Access Compliance Report

(Curb Ramps)

Intersection ID: 50578	Main Street: PAPER_TREE_RD	Cross Street: BENDING_BRANCH_RD	Location: SE
ADA ID: 1749F27465AB	Ramp Type: Perp	Initial Pass/Fail: Fail	Overall Compliance: No
Codes/Mitigation Info/Possible Solution		Field Measurements/Component Compliance	
Severity Score: 13.75

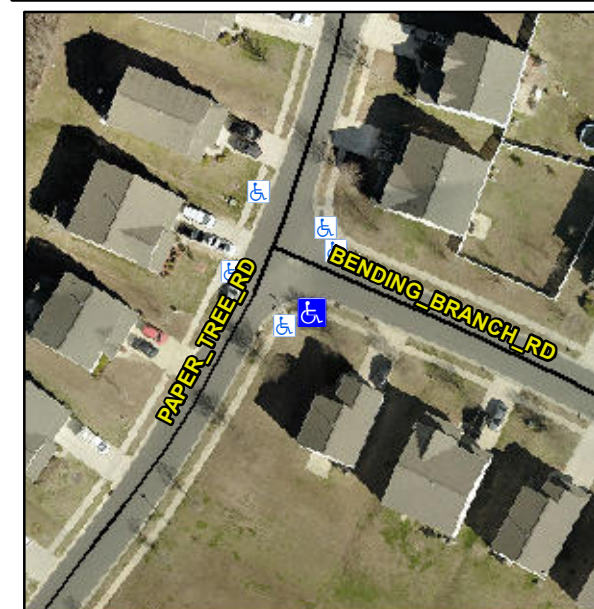
Not Found, R304.2.2, R304.5.3

Compliance	Description	Data	Compliance	Description	Data
N/A	Ramp Length (in)	46.5	No	Ramp Slope (%)	9.6
Yes	Ramp Width (in)	48.0	No	Ramp XSlope (%)	4.4
N/A	Flare Type LT	N/A	N/A	Flare Type RT	N/A
N/A	Flare Slope LT (%)	N/A	N/A	Flare Slope RT (%)	N/A
N/A	Flare Traversable LT?	N/A	N/A	Flare Traversable RT?	N/A
N/A	Landing Length (in)	N/A	N/A	DWS Provided?	N/A
N/A	Landing Width (in)	N/A	N/A	DWS Contrast?	N/A
N/A	Landing Slope (%)	N/A	N/A	DWS Length (in)	N/A
N/A	Landing X Slope (%)	N/A	N/A	DWS Full Width?	N/A
N/A	Landing Curb? (Y/N)	N/A	N/A	DWS Offset (in)	N/A
N/A	Shared Landing?	N/A			
N/A	Gutter Ponding?	N/A	N/A	Gutter Slope (%)	N/A
N/A	Gutter Lip Ht (in)	N/A	N/A	Gutter X Slope (%)	N/A
N/A	Painted X Walk1?	No	N/A	Painted X Walk2?	N/A
	X Walk 1 Direction	To E		X Walk 2 Direction	N/A
N/A	X Walk 1 Width (in)	N/A	N/A	X Walk 2 Width (in)	N/A
	X Walk 1 Slope (%)	0.3		X Walk 2 Slope (%)	N/A
	X Walk 1 X Slope (%)	2.9		X Walk 2 X Slope (%)	N/A

Remove & Replace Entire Ramp.
